CONTINUING ELIGIBILITY INSPECTION (CEI) REPORT

FOR HURRICANE & SHORE PROTECTION PROJECTS

- 1. Project Name: Matafao Shore Protection Project
- 2. Date of Inspection: April 10, 2002

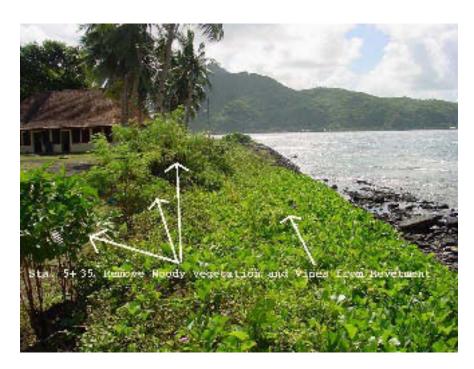
a. Sta. 2+55, Remove vines from crest of the structure.
